Docket ID No. EPA-HQ-ORD-2011-0895  
Sean Kelly; March 8, 2012

Comments on EPA Draft Research Report:  
Investigation of Ground Water Contamination  
near Pavillion, Wyoming

United States Environmental Protection Agency, Draft Research Report: Investigation of Ground Water Contamination near Pavillion, Wyoming. Released December 8, 2011

**Figure 2.)** Modified from Draft Report Figure 7, (Draft Report Pg. 11). Intervals in the upper Wind River Formation exhibit a good to excellent lateral stratigraphic continuity between the two deep EPA monitor wells.

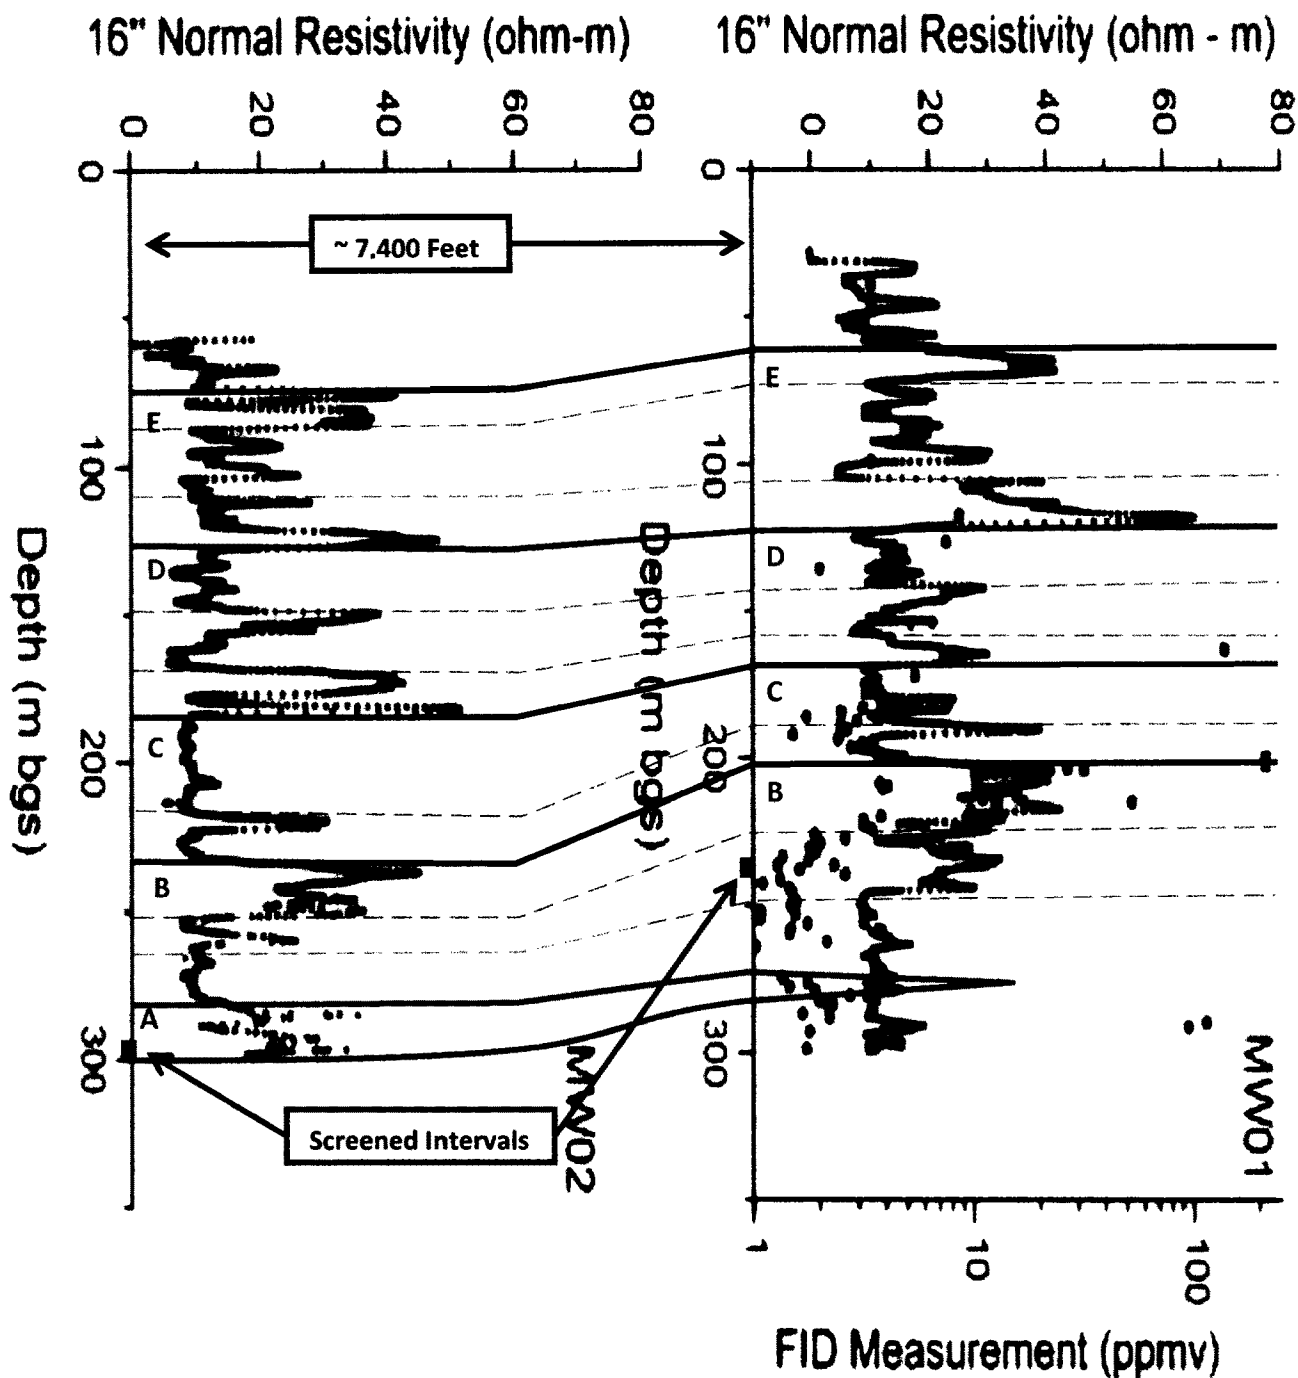
**The EPA has not performed the basic geological analyses and interpretations required to make and support the statement "there is little lateral and vertical continuity to hydraulically fractured tight sandstones and no lithologic barrier (laterally continuous shale units) to upward vertical migration of aqueous constituents of hydraulic fracturing in the event of excursion from fractures".** The EPA should begin by closely examining the log data from the two deep monitor wells shown in Draft Report Figure 7, (Draft Report Pg. 11). Contrary to what is stated in Draft Report Pg. 32, it is quite obvious there is actually good to excellent lateral stratigraphic continuity over the approximately 7,400 ft. separating the two deep EPA monitor wells **Figure 2**. Individual sandstone prone intervals (higher resistivity) and shale prone intervals (lower resistivity) show good to excellent continuity between the two deep EPA monitor wells (see markers B, C, D and E, and the dashed lines on **Figure 2**.).

A more accurate identification of sandstone prone intervals in the two deep EPA monitor wells would have been obtained if the EPA would have utilized the natural gamma ray and density data in addition to the resistivity data to determine screen placement. The EPA must have been aware that they were placing the screened interval in the Randall MW01 monitor well at depth with the potential for significant natural gas concentrations based on the mud log shows obtained while drilling the well. See Figure 2.

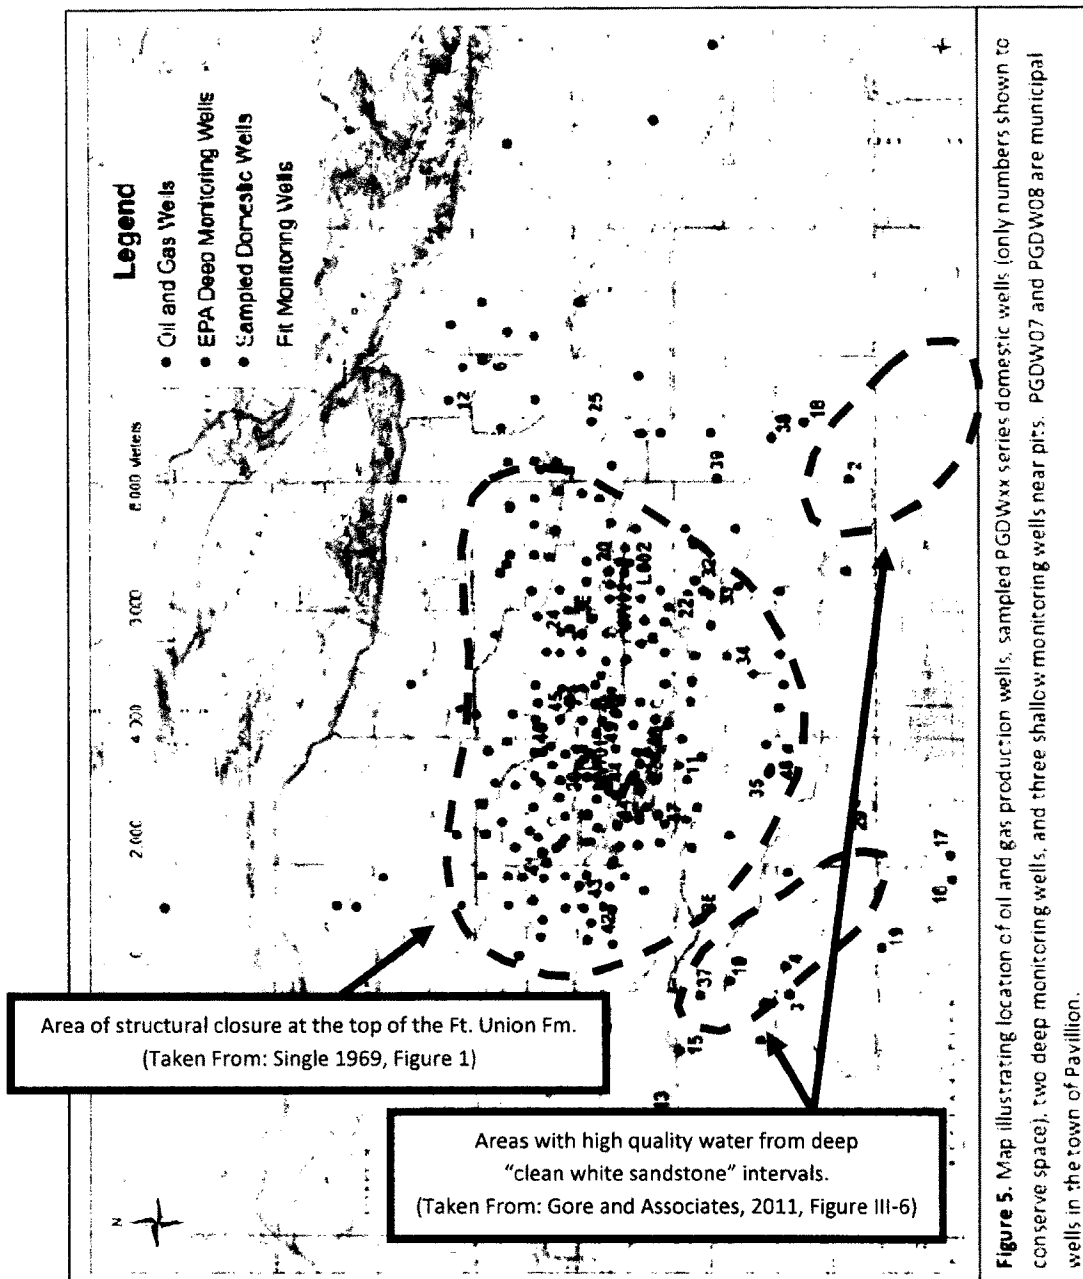
gas production wells are located within the area of structural closure **Figure 3** and **Figure 4**. This is the area where natural gas which is thermogenically generated from source rocks buried deeper in the basin has migrated upward through a natural buoyant process and is now trapped in shallower Wind River and Fort Union reservoirs in the area of structural closure. This is how the natural gas accumulation at Pavillion Field naturally formed, and why the gas productive wells are concentrated in the area of structural closure. Natural gas at all depths would be expected to be significantly more prevalent inside of the area of structural closure than in areas outside of the area of structural closure. Any domestic water wells drilled inside the area of structural closure and therefore within the productive limits of Pavillion Field would also be drilled where the concentration of gas productive wells is the greatest (and thus more likely to be located proximal to gas productive wells). Any domestic water wells drilled in the area of structural closure would also be located in the area where natural gas has migrated from deeper sources and has naturally accumulated in shallow strata located within the Pavillion Field anticlinal trap. Even very shallow porous zones located inside of structural closure would be expected to have concentrations of residual or dissolved methane as natural gas migrated through these intervals on the way to the surface (**Sean Kelly-Attachment No.3**).

Two areas with high quality water from deep "clean white sandstone" intervals in close proximity to Pavillion Field are identified by Gore and Associates (2011). These areas of high quality water are located outside of the area of structural closure and therefore outside of the productive limits of Pavillion Field **Figure 3**.

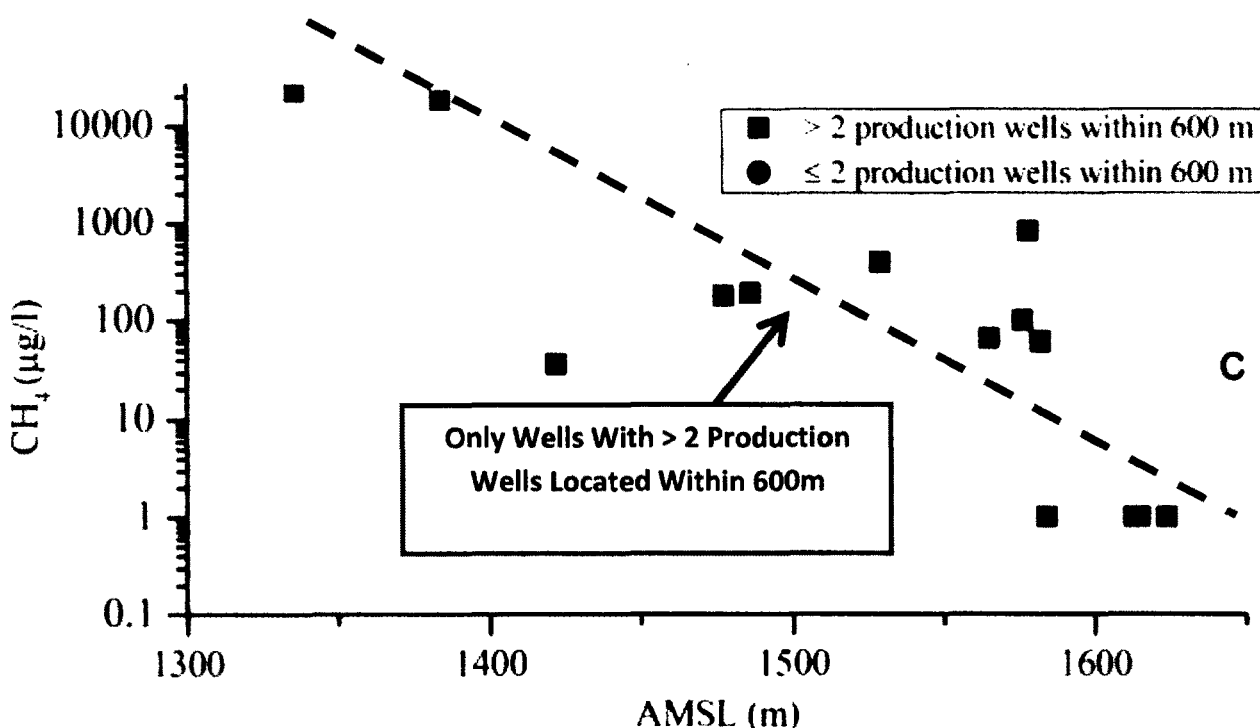
If only the domestic wells with more than 2 producing wells within 600 m are considered (Draft Report Figure 18(c) (Draft Report Pg. 28), there is a good correlation of increasing methane concentration with depth. The wells with more than 2 producing wells within 600 m are most likely to be located within the area of structural closure and therefore within the productive limits of the Pavillion Field anticlinal closure. It would be expected that methane concentrations would increase with depth for all wells drilled within the productive limits of Pavillion Field **Figure 5**.

**Figure 6.)** Modified from Mason et al. 2005 Figure 7. Almost all of Township T-3N, R-2E which includes the Town of Pavillion and the study area for the Draft Report is identified as having high aquifer sensitivity to surface contamination.

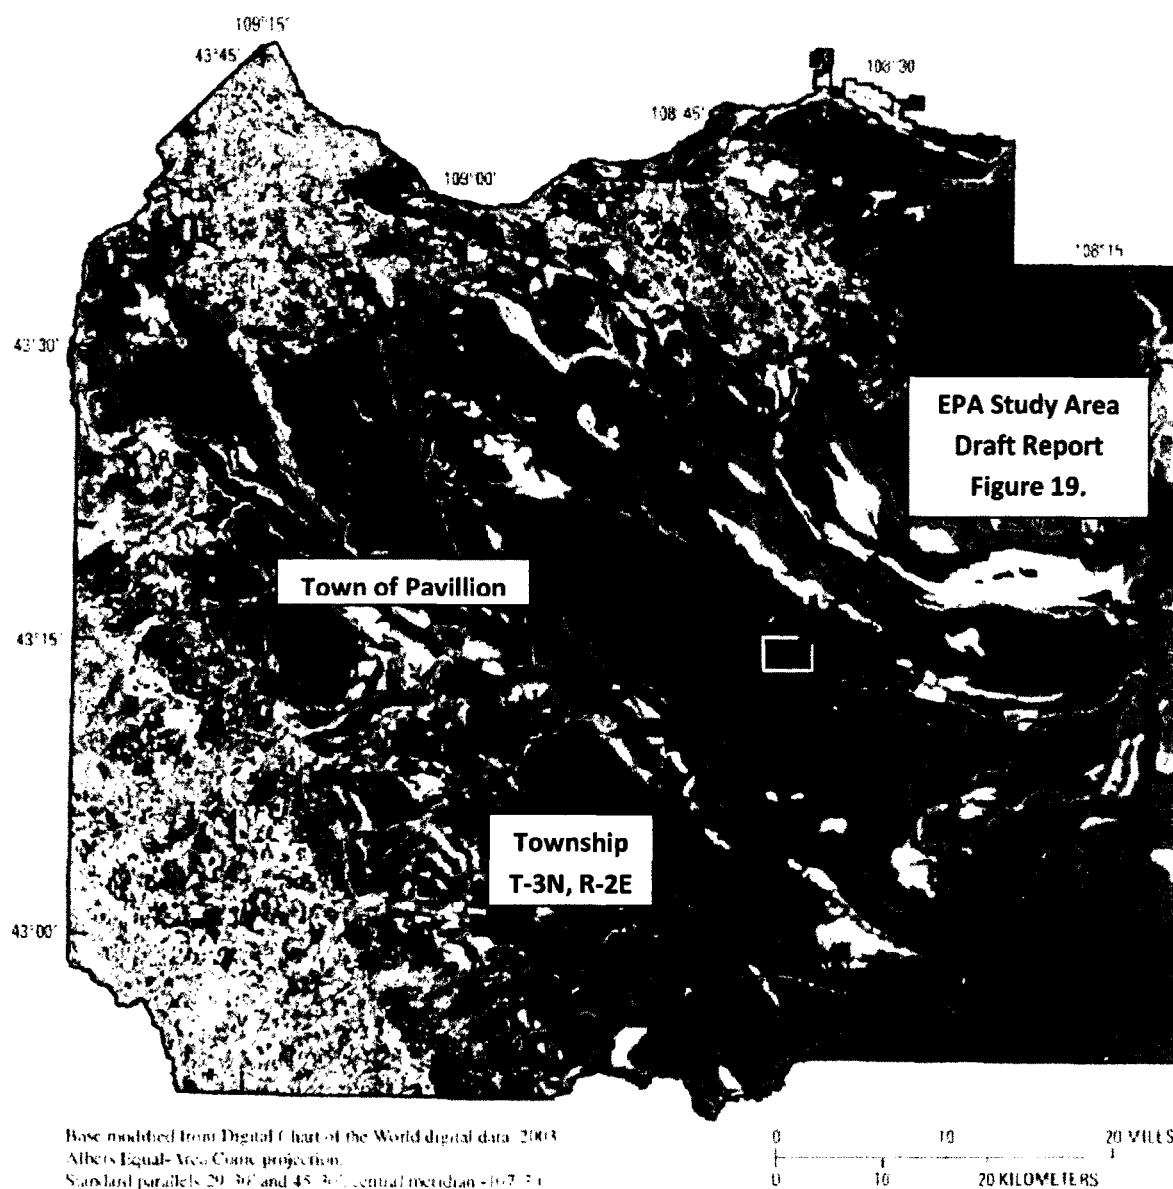
10. Failure to thoroughly investigate potential causes of contamination other than oil and gas operations. Mason et al. (2005) generated a regional map showing surficial aquifer sensitivity to surface contamination as part of their study **Figure 6**. The parameters used to identify an area's sensitivity to contamination included: depth to initial ground water, hydrogeologic setting, soil characteristics, aquifer recharge, land surface slope and vadose zone properties. Almost all of Township T-3N, R-2E which includes the Town of Pavillion and the study area for the Draft Report is identified as having high aquifer sensitivity to surface contamination **Figure 6**.

**Figure7.)** Modified from Mason et al. 2005 Figure 9. At least six locations with either potential or known ground water contamination were identified in Township T-3N, R-2E as of 1998.

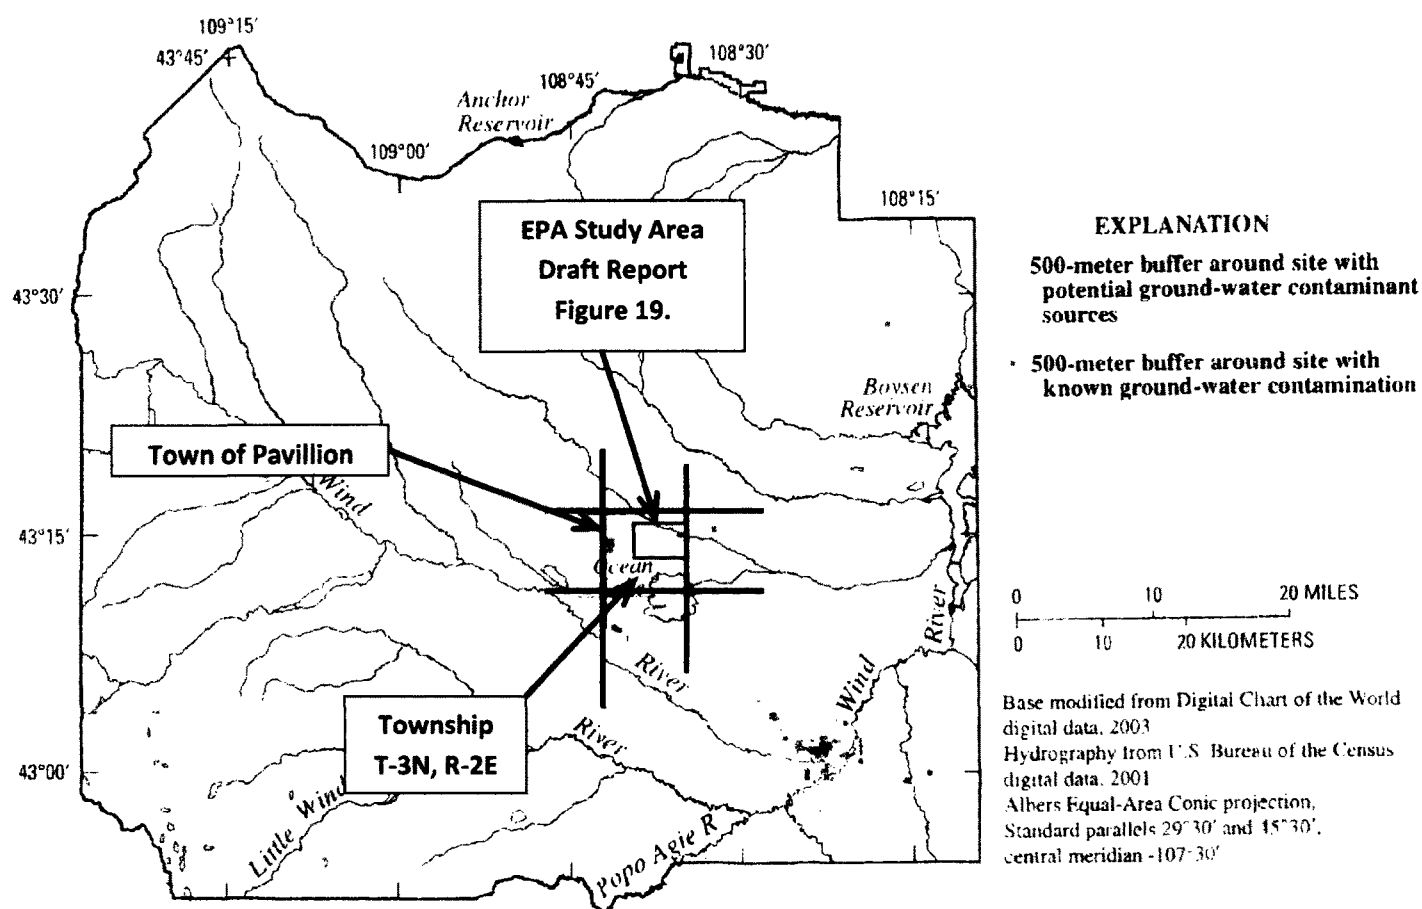
Mason et al. (2005) also compiled and mapped all known sites with potential ground water contaminant sources and all sites known to have ground water contamination based on the Wyoming Department of Environmental Quality's 1998 Wyoming Pollution Point Source database **Figure 7**. The sites with potential ground water contaminant sources includes: the locations of non-leaking underground storage tanks, above-ground storage tanks and municipal landfills. The sites with known ground water contamination includes: the locations of leaking underground storage tanks and ground water pollution control areas Mason et al. (2005). At least six locations with either potential or known ground water contamination were identified in Township T-3N, R-2E as of 1998 **Figure 7**.

**Figure 8.)** Modified from Mason et al. 2005 Figure 10. At least one National Pollution Discharge Elimination System site location had been identified in Township T-3N, R-2E as of 1998.

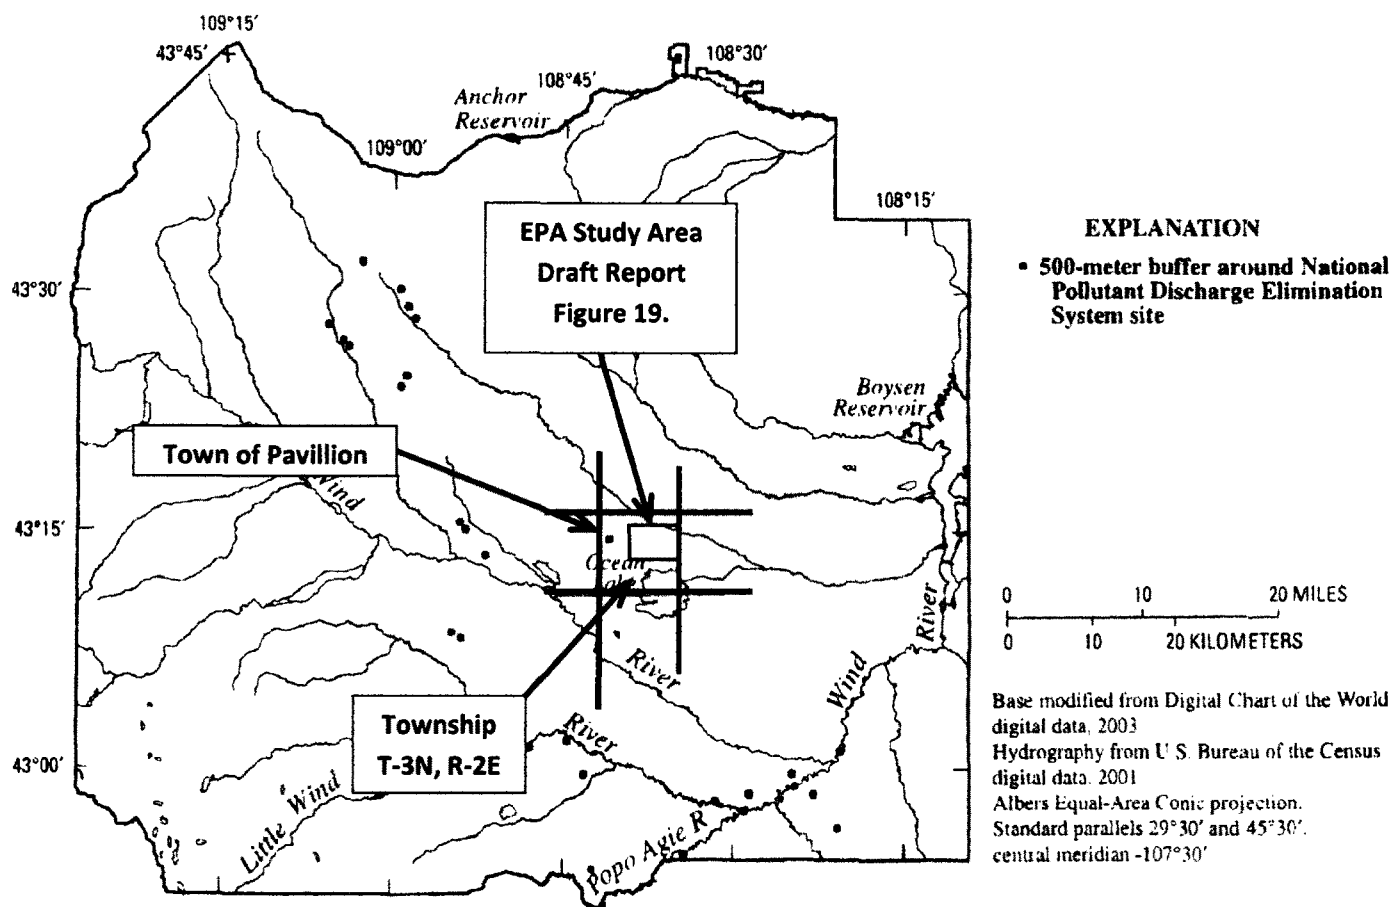
Mason et al. (2005) also identified and mapped all known locations of National Pollution Discharge Elimination points based on the Wind River Environmental Quality Commission database **Figure 8**. At least one National Pollution Discharge Elimination System site location was identified in Township T-3N, R-2E as of 1998 **Figure 8**.
